Factory Service Bulletin

SUBJECT: MEMORYMOOGS BELOW BULLETIN: 835
SPONTANEOUS POTENTIOMETER EDITING

DATE: November 22, 1983 (Supersedes earlier versions)

R.S.C. PRINTED CIRCUIT BOARD SCHEMATIC (BOARD NO. 6)

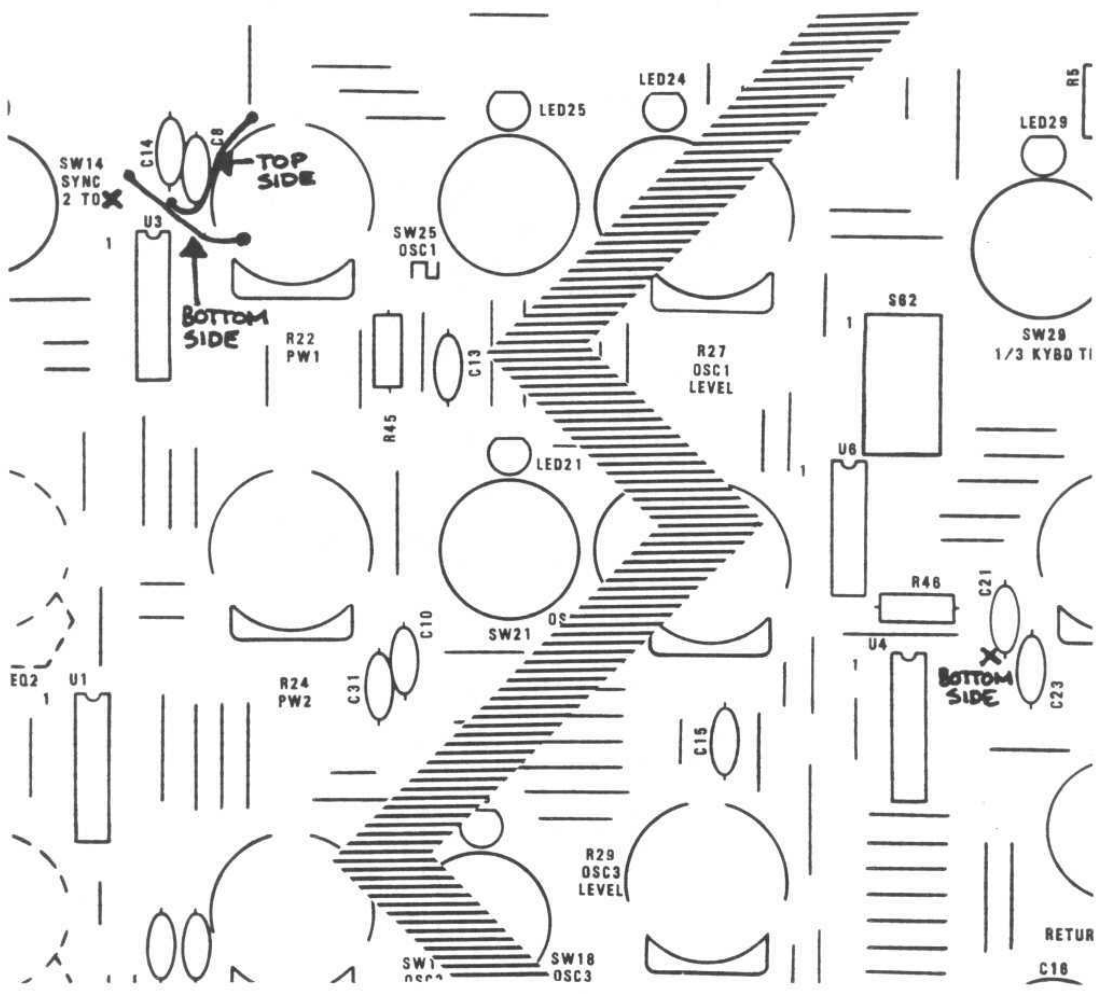
CAUSES: Digital to analog ground loop and no +15 volt power supply to U3 on RIGHT SIDE CONTROL board. High frequency HASH on MUX BUSS on DMUX board.

SPONTANEOUS POTENTIOMETER EDITING (BELOW S/N 2531)
Modify the RIGHT SIDE CONTROL board on the bottom side with the board mounted in place. Cut the trace between C21 and the jumper connected to U6 pin 7. Follow the diagram provided. This is necessary because the digital ground was inadvertently tied to the analog ground, resulting in a ground loop.

Also cut the trace between C14 and the jumper connected to U3 pin 8 at the "1" of the screened information "SYNC 2 TO 1". "Tack-solder" a 1.8" (46mm) insulated jumper between the ground side (mounting tab) of R22 and the C14 side of the trace cut at the "SYNC 2 TO 1" location - follow the diagram provided.

SOLUTION: EDITS ON POWER UP (BELOW S/N 1795)
On an AS REQUIRED BASIS ONLY, add an insulated jumper ON THE TOP (COMPONENT) SIDE of the RIGHT SIDE CONTROL between C14 (side nearest U3) to the jumper over R22 (closest to the edge of board).

NOTE: If this modification is inadvertently soldered to C8 instead of C14, it will cause constant editing and burn out R22, the PW1 pot. THIS JUMPER WIRE MUST BE ON THE COMPONENT SIDE OF THE BOARD.

NOTE: ALL FLUX MUST BE REMOVED FROM THE BOARD BY THE JUMPER WIRE, OR THE EDITING PROBLEM WILL WORSEN FROM FLUX LEAKAGE. The solder (back) side of the board should also be checked for flux that may have "run" through the board by the top jumper and C14 and removed if present.
